**SAN ANTONIO WATER SYSTEM
REPLACE STEVENS RANCH PUMP STATION GROUND STORAGE TANK
SAWS Job No. 15-6104
Solicitation No. CO-00078-RA**

**ADDENDUM NO. 2
July 29, 2016**

**Consulting Engineer: River City Engineering, PLLC
TBPE Registration No. F-1546**

SHEET NO. **C-13**
 19 of 33 SHEETS

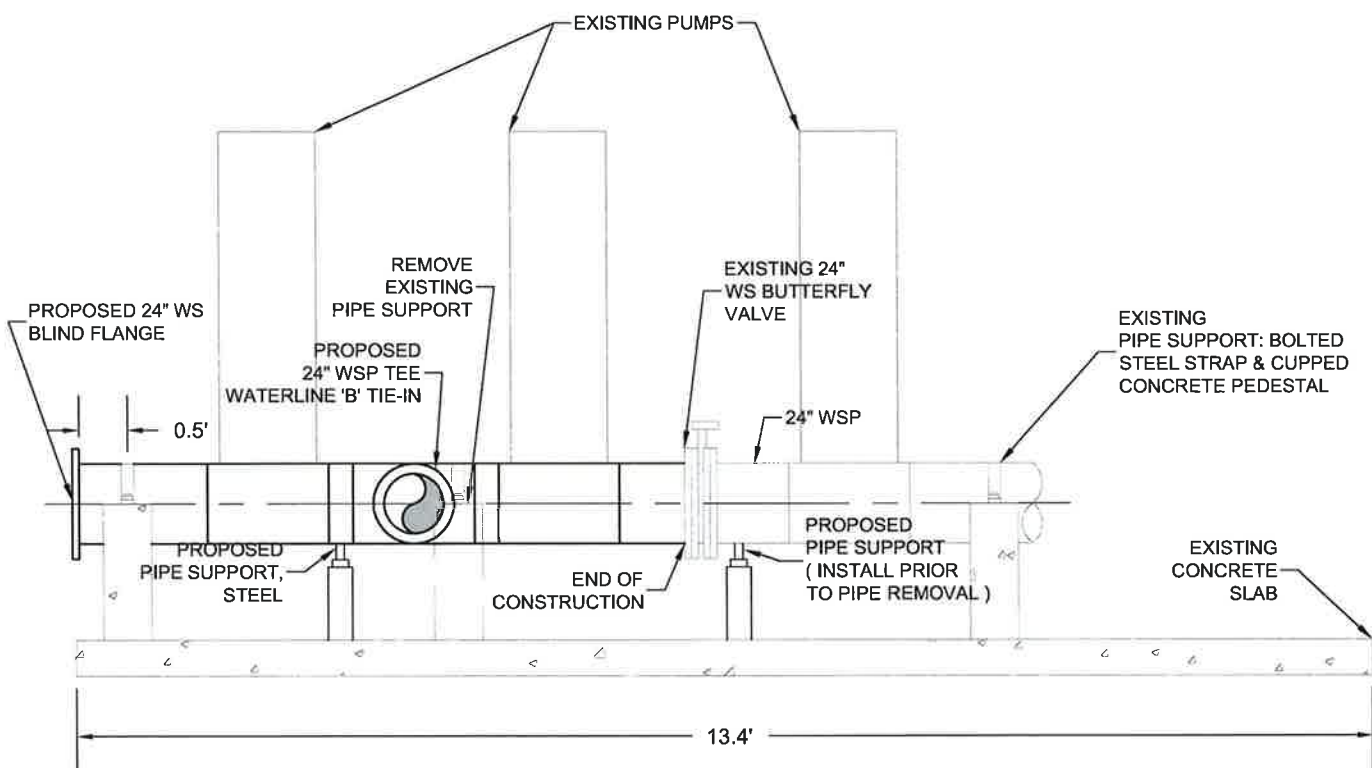
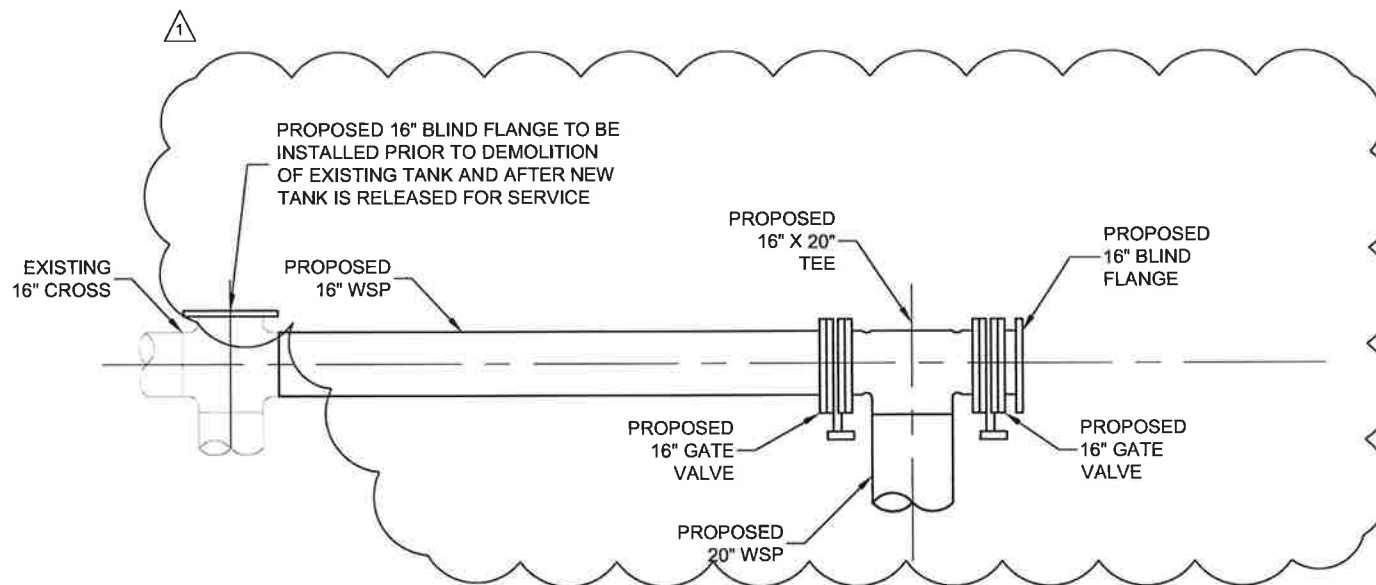
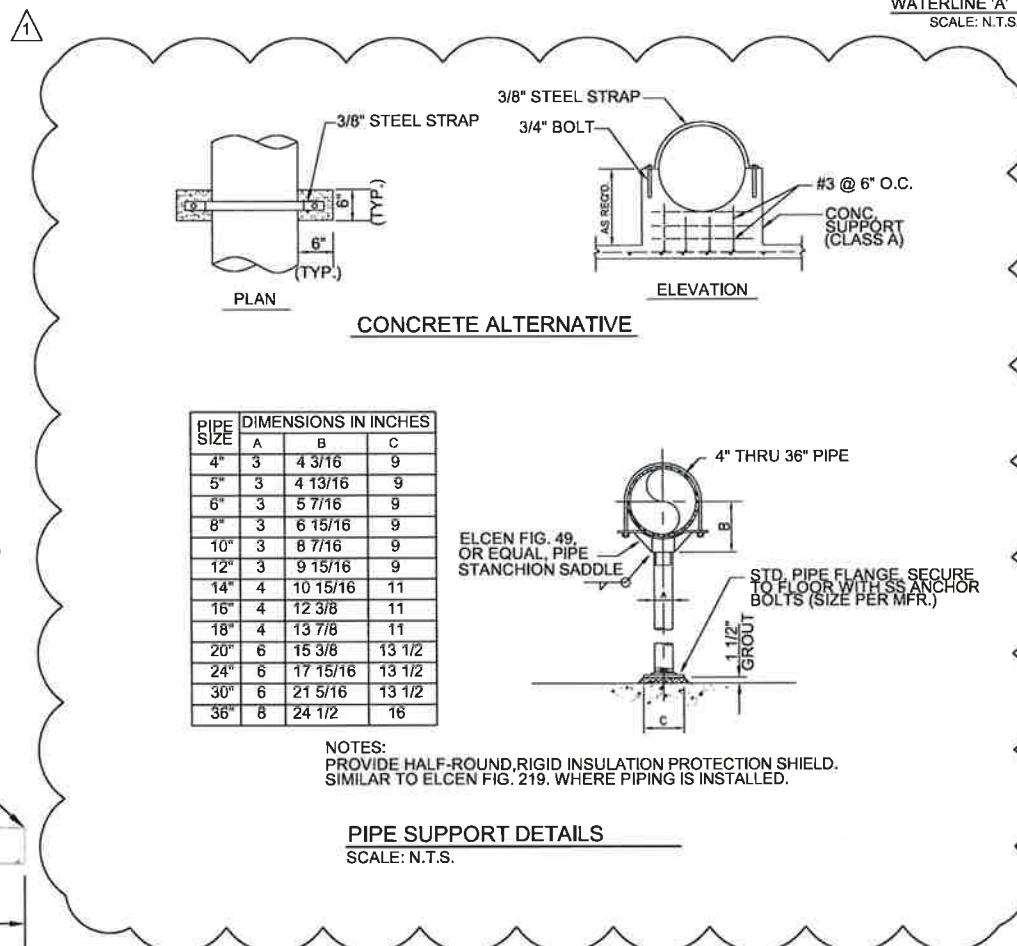
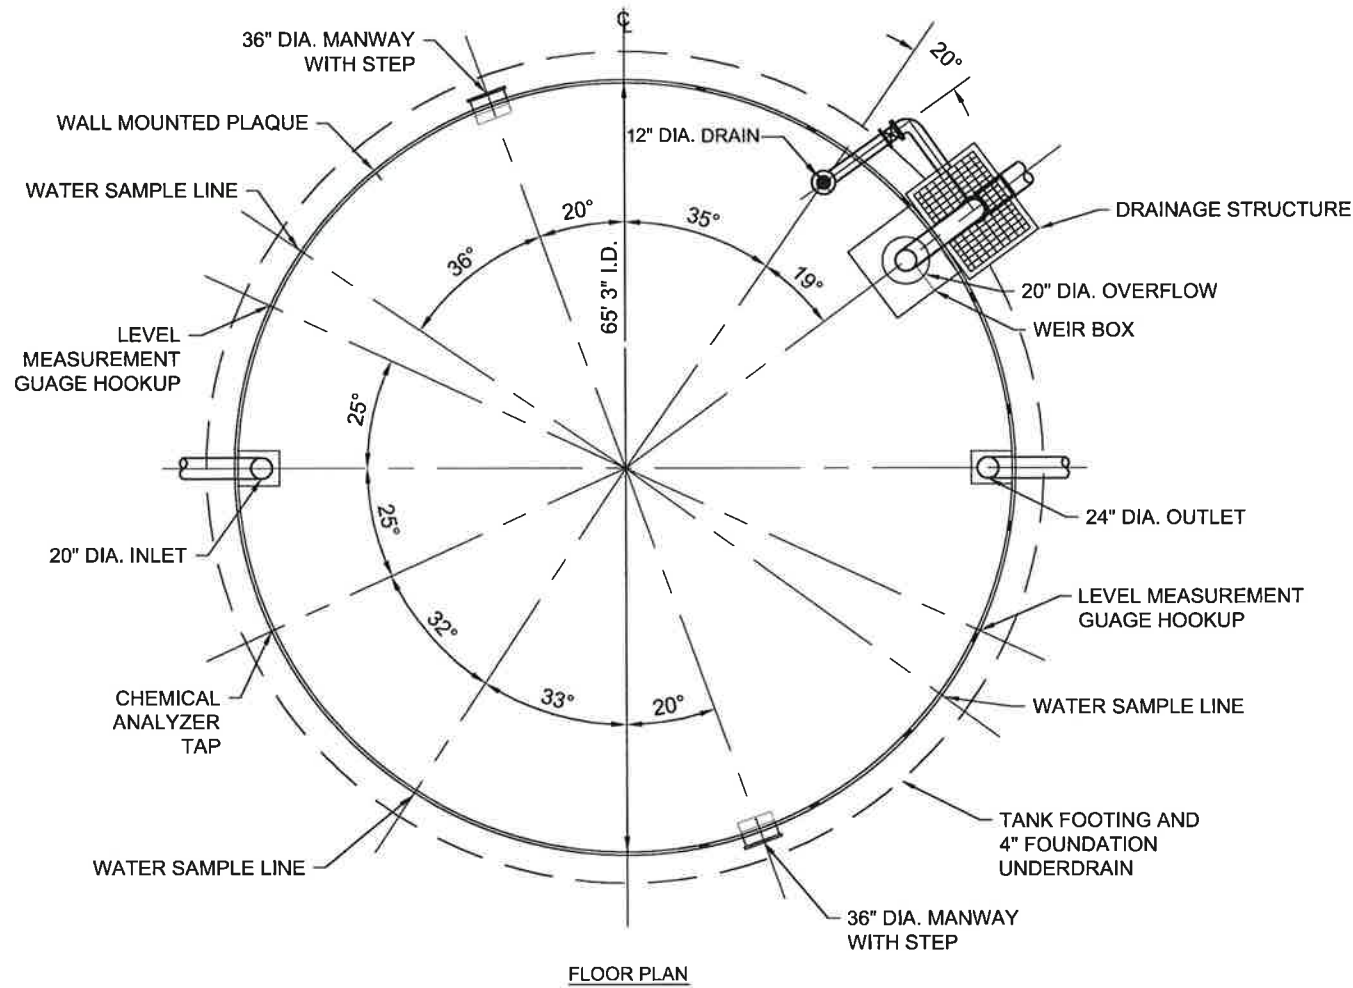
4. QUESTION: On sheet C13 waterline 'A' tie in. You show the cross as existing but on sheet C7 the cross is shown as proposed. Please clarify.

7. QUESTION: On drawing C-13 will there be any pipe support details for the 24 pipe header?

view, both the tee and the isolation valves in this area are called out as 20" in size and the isolation valves are called out as butterfly valves. On plan sheet C-13, the waterline 'A' tie-in detail has all items as 16" in size except for the 20" branch. Please clarify the size of this line and the types of isolation valves.

RESPONSE: This is an existing cross: Please reference Item No's. 34 and 37 in the Drawing Section below and attached Sheet C-7 and C-13 modifications.

RESPONSE: Pipe support details have been added. Please reference Item No. 37 in the Drawings Section below and attached Sheet C- 13 modifications.

RESPONSE: Sheets C-7 and C-13 have been modified to address the various concerns. Please reference Item No's. 34 and 37 in the Drawings Section below and attached Sheet C-7 and C-13 modifications.

SHEET NO T-1

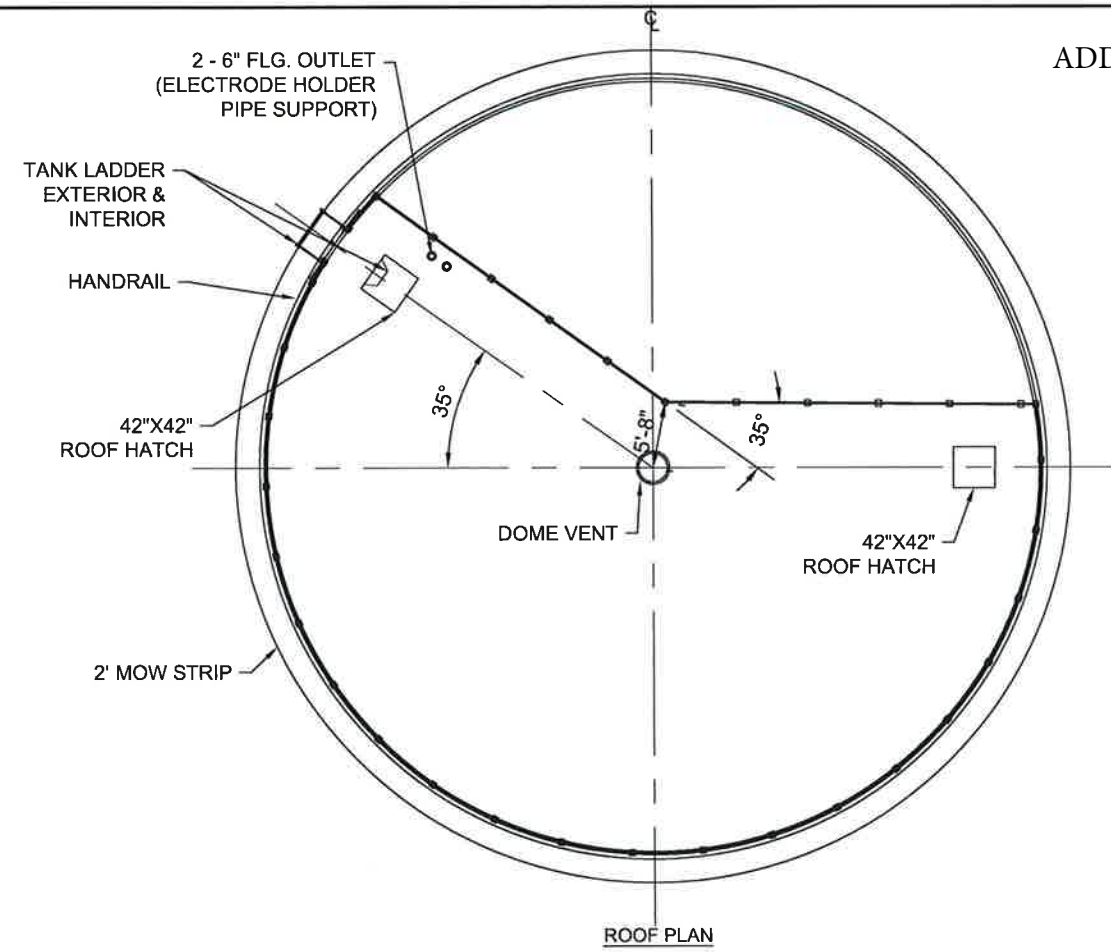
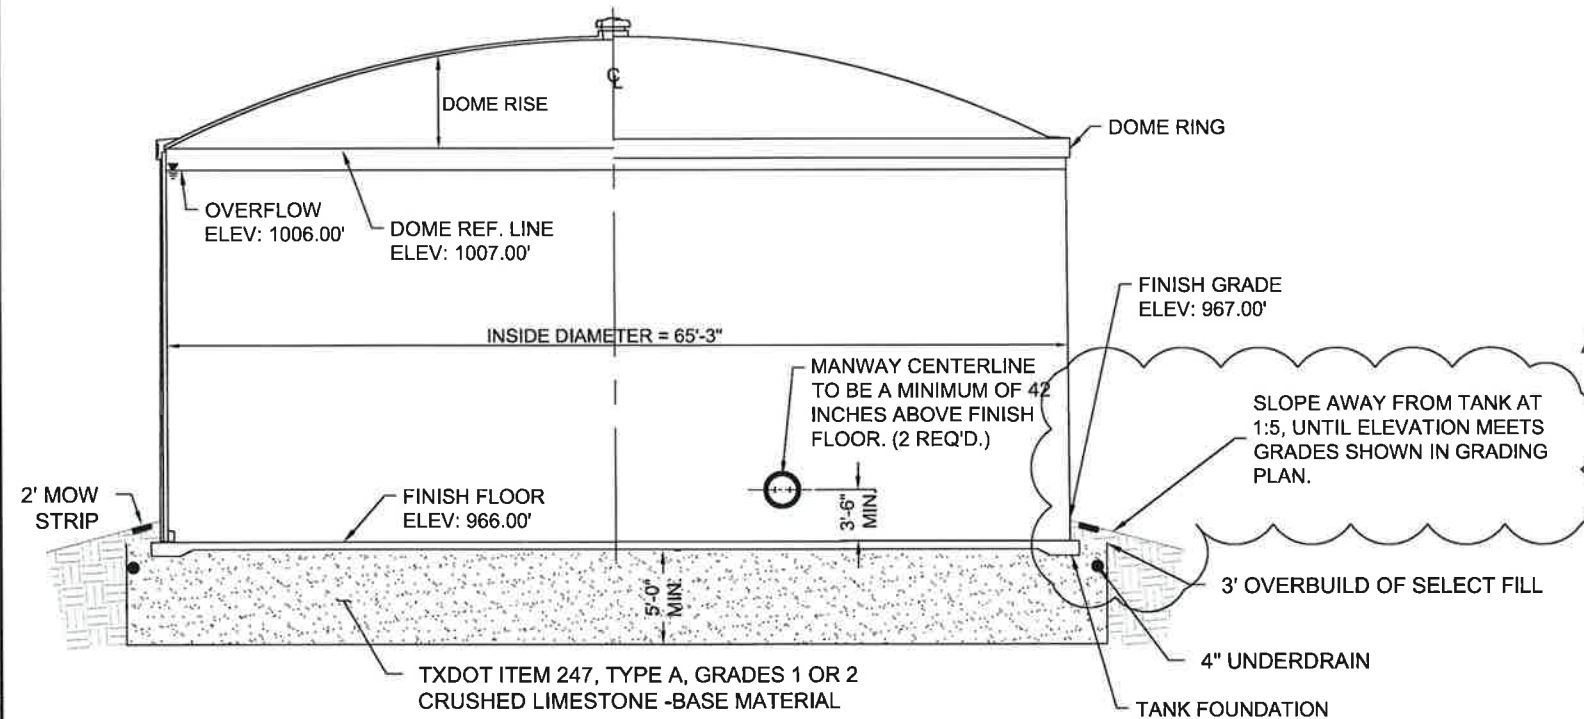
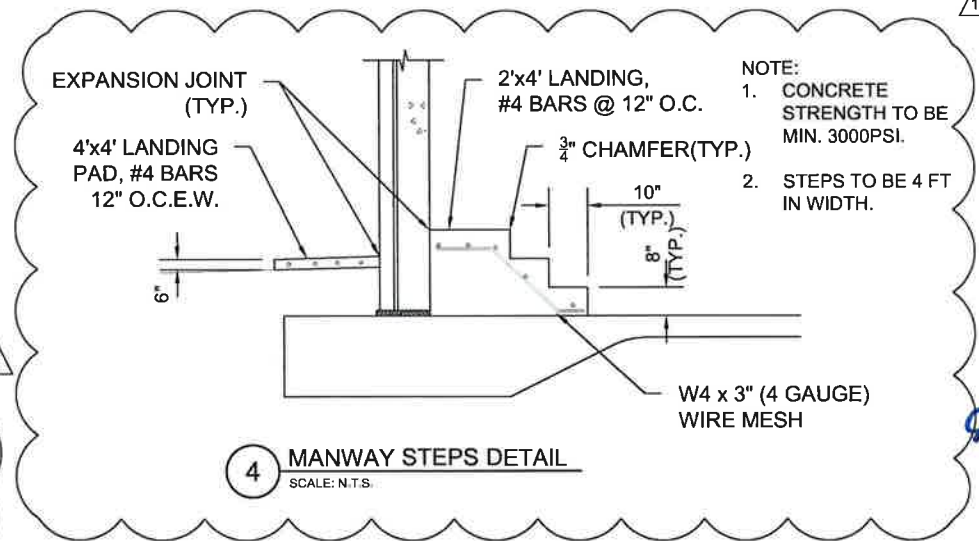
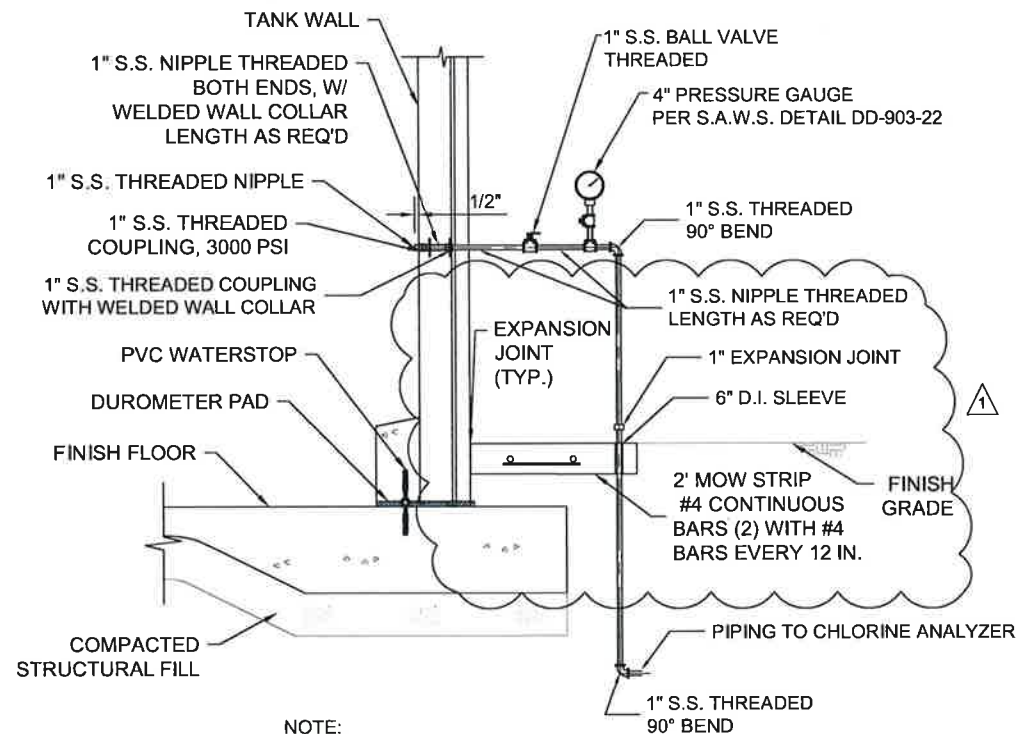
17. QUESTION: Sheet T-1, Ground Storage Tank Elevation, indicates the finish grade around the tank perimeter is at elevation 966.00. The Geotechnical Report recommends the tank foundation should be founded at least two feet below final adjacent grade. We typically recommend a minimum of 12" of backfill be placed above the finish floor elevation and sloped away from the tank to promote positive drainage

and proper erosion protection of the footing. Please confirm the required backfill elevation adjacent to the tank.

18. QUESTION: Sheet T-1, Ground Storage Tank Floor Plan, indicates the manways with a step. The tank manways will be located near the base of the wall to provide easy access into the tank. Please confirm if a step is required for each manway. If a step is required, please provide material information and a detail of what is required.

RESPONSE: Sheet T-1 has been modified to reflect the recommendation from the Geotechnical Report. Please reference Item No. 38 in the Drawings Section below and attached Sheet T-1 modifications.

RESPONSE: A step is required for each manway and a detail has been included in this addendum. Please reference Item No. 38 in the Drawings Section below and attached Sheet T-1 modifications.

1 OVERFLOW PIPE DETAIL
SCALE: N.T.S.

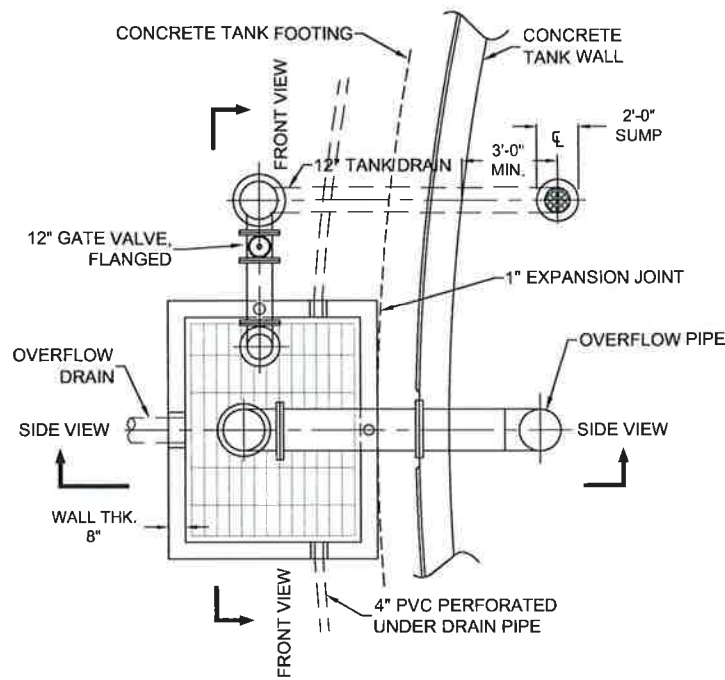
13. QUESTION: Specification Section 13414 – Precast, Prestressed Concrete Ground Storage Tank; Page 8, Article 2.10.A.5, indicates a 24-inch overflow pipe; however, plan sheet T-4 indicates a 20" overflow pipe. Please confirm whether a minimum pipe size is required and/or if the tank manufacturer may be responsible for the design and sizing of the overflow pipe and weir cone based on the project overflow rate.

20. QUESTION: Sheet T-4, Overflow Pipe Detail, indicates the design overflow elevation is 1011' alluding to a design liquid level of 45-foot. Please confirm the design overflow elevation is 1006' as indicated on Sheet T-1, which would be a 40-foot liquid level.

21. QUESTION: Sheet T-4, Overflow Pipe Detail, indicates a pipe support bearing on the tank footing which may require a thickened footing to tolerate loadings. Please confirm the pipe support may be anchored into the overflow drainage structure.

RESPONSE: Section 13414 and Plan Sheet T-4 have been modified to address the concern regarding the sizing of the overflow piping. Please reference Item No's. 28 and 31 in the Specifications Section below and attached Section 13414-8 and Plan Sheet T-4 modifications.

RESPONSE: Sheet T-4 has been modified to reflect an overflow elevation of 1006' as indicated on Sheet T-1. Please reference Item No. 40 in the Drawings Section below and attached Sheet T-4 modifications.

RESPONSE: Sheet T-4 has been modified to indicate that the overflow pipe support shall be anchored into the overflow drainage structure. Please reference Item No. 40 in the Drawings Section below and attached Sheet T-4 modifications.
